MANATEE COUNTY
FLORIDA

SUBJECT: **Request for Quotation # 13-2025-DS**
Three Phase Uninterrupted Power System

ADDENDUM # 4

DRAWING TITLE:
66TH STREET LAB UPS STUDY POWER PLAN
REVISION 1, Corrected existing walls to match actual 08/30/2013

SHEET No.:
E3.0

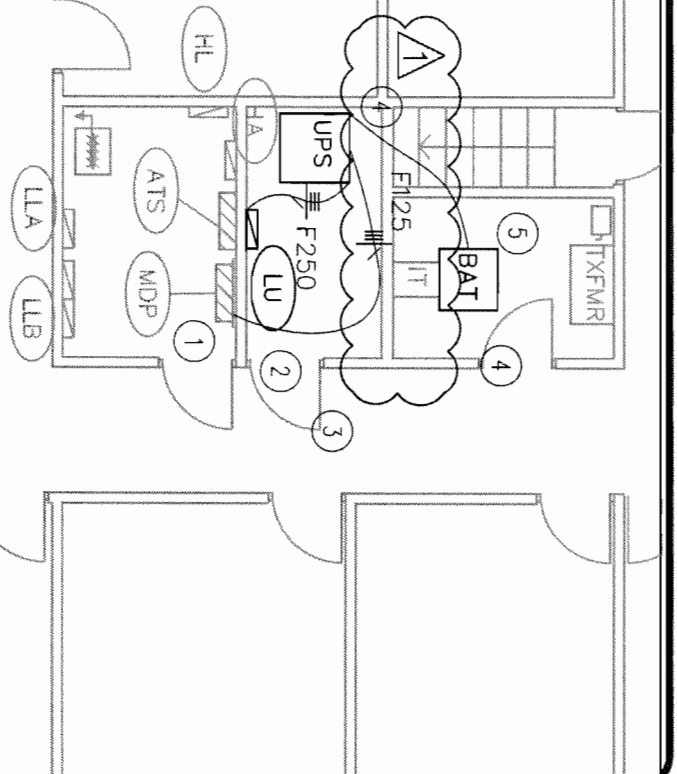
1. Provide a UPS that will fit into the UPS Room and a battery system that will fit into the IT Room next door. There is 70" of linear space for the UPS and additional space next door in the IT Closet that can work for the battery system. The width of the room is 70" the length is approx. 120". With approx. 48" of available length, the max dimension (base – length/width) may not be greater than 39".
2. Attached please find the revised E3.0 (66th Street Lab UPS Study Power Plan, rev. 1 dated 8/30/13). The attached drawing supersedes the previously submitted placement drawing, by way of this Addendum # 4 remove and replace accordingly.
3. There is physical space for the batteries in an alternate location. This could be the IT Room. Items may need to be moved slightly to meet the code requirements.
